Seattle Design Commission

MINUTES OF THE MEETING

June 15 2006

New Rainier Vista – 31st Avenue South – Street/Alley Vacations
Jefferson Park Expansion – Phase 1 Development
Arboretum Pacific Connections
Planning Division Update
Alaskan Way Viaduct and Seawall
Olympic Sculpture Park site tour

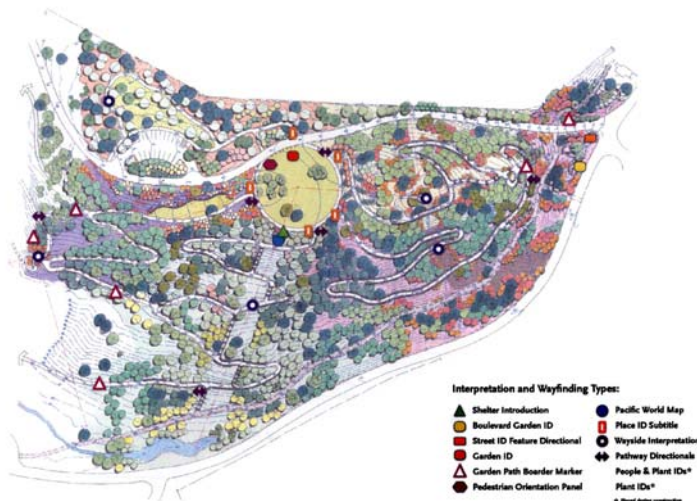
The Commission appreciates the update on the shelter pavilion and wayfinding elements, but still does not recommend approval with the following concerns:

- the designs show a lack of understanding of how the elements work together
- the use of inappropriate shapes and forms and overall aesthetic remain an issue

- Please explain techniques for building a green roof
 - use of soil, plants, etc.
- The design needs work, look at the Japanese Garden
- The stairs look too formal for the other, very informal structure. The two elements pull away from each other
- Suggest making stairs into an overlook
- Need to see another level of drawings. The design is not appropriate to the place - no overall sense of appropriateness for the arboretum.
- There is an awkward aesthetic relationship in the site design, and the scale and materials, of the kiosk.
- Focus of the overlook design is on a formal circle, but not sure how it really works programmatically with the larger site
- Need to see sections and a more detailed site plan
- This shelter represents approx. \$60,000 out of a \$6.0 million project.
